PRELIMINARY & FINAL DRAINAGE REPORT
for
WIDEFIELD PK-8 SCHOOL

Widefield, CO

May 2018

Detention Basin Outlet Structure Design

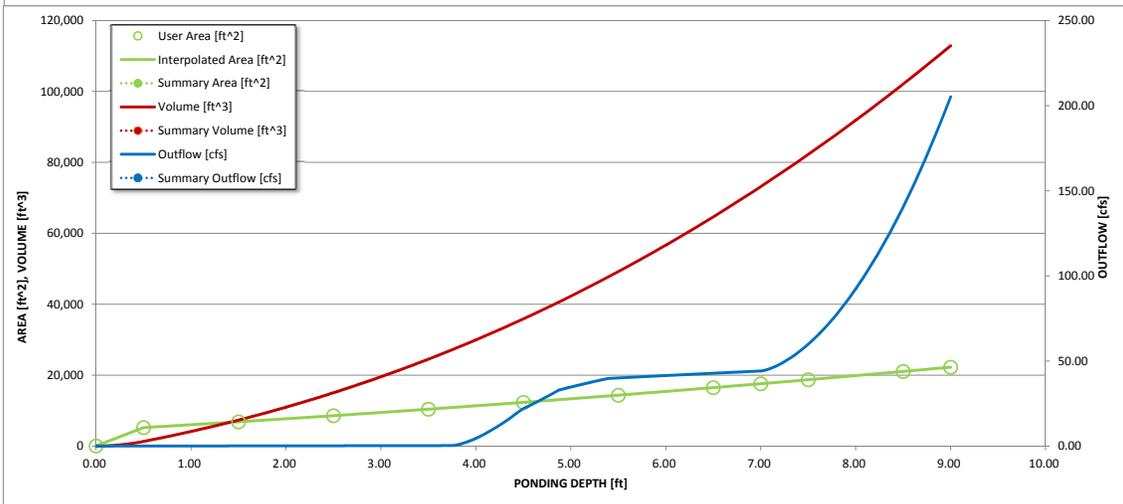
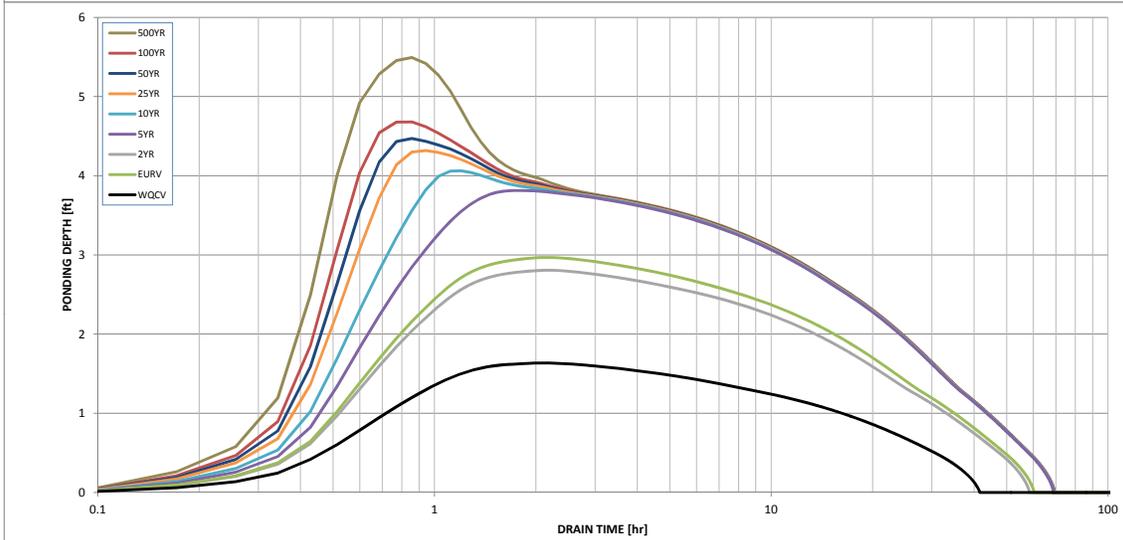
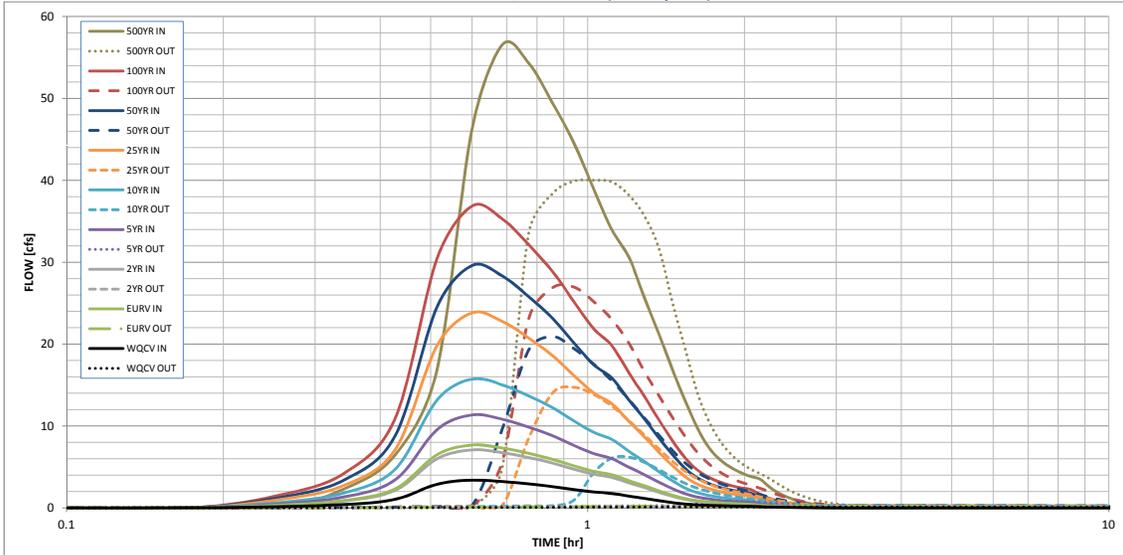
consider enlarging grate area.

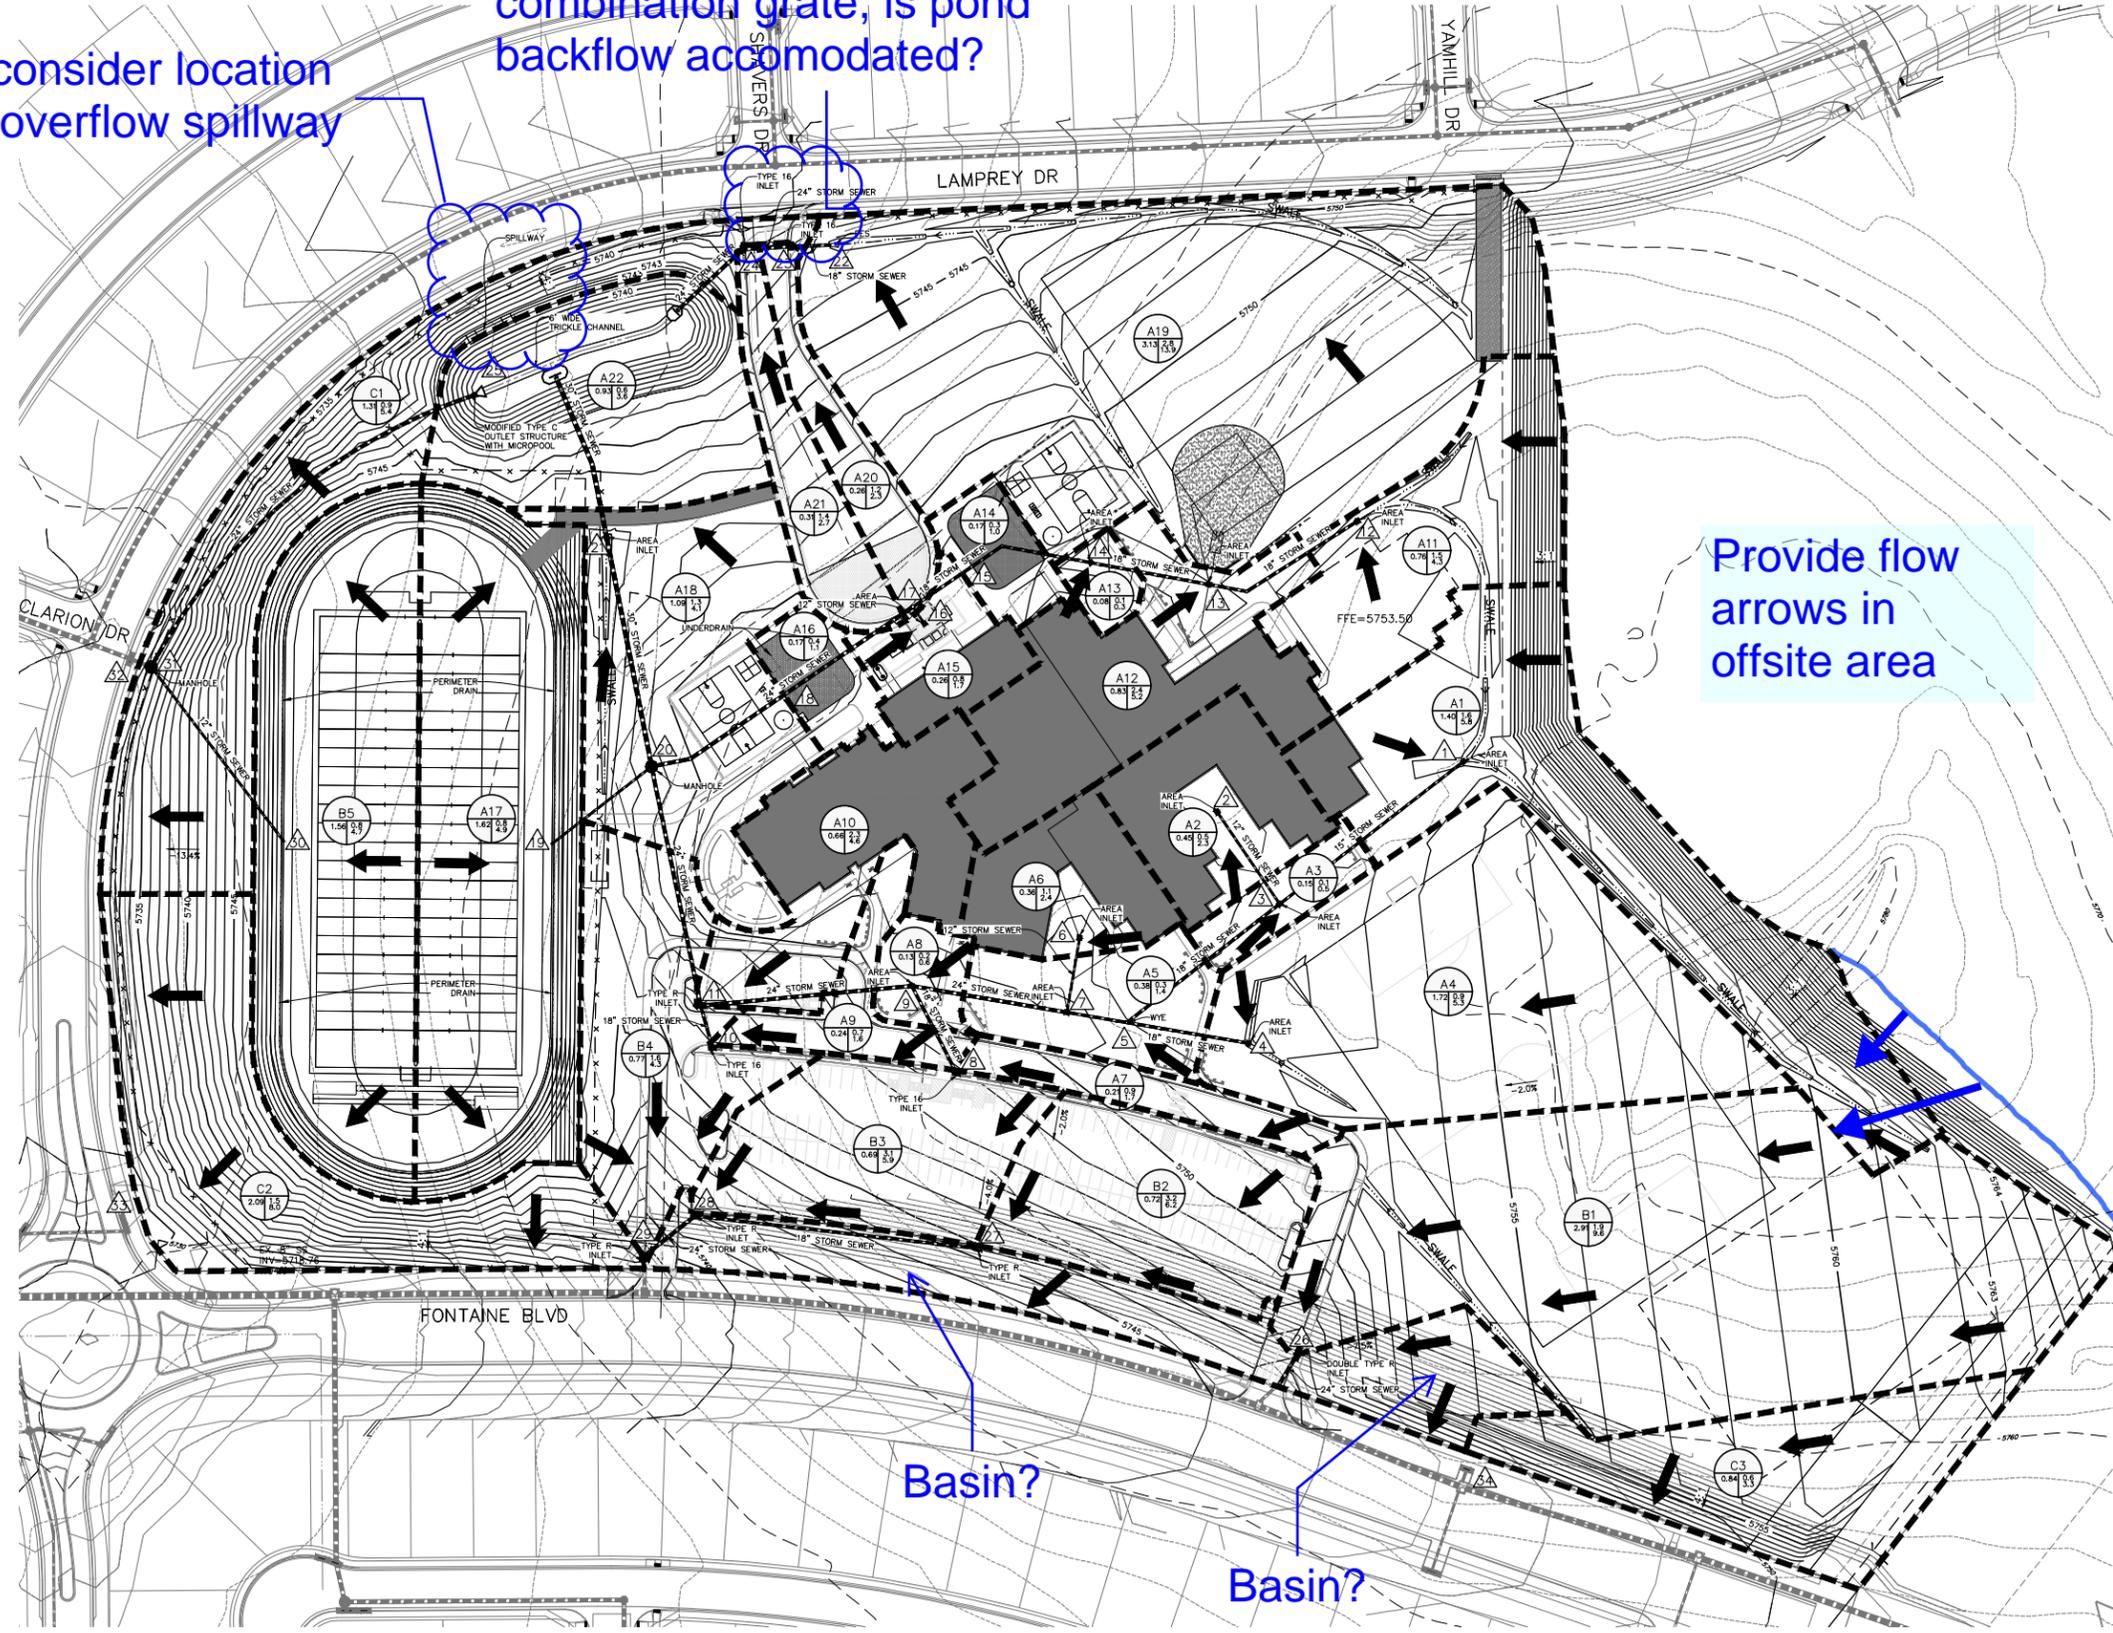
What kind of inlets are these? If combination grate, is pond backflow accommodated?

reconsider location of overflow spillway

Provide flow arrows in offsite area
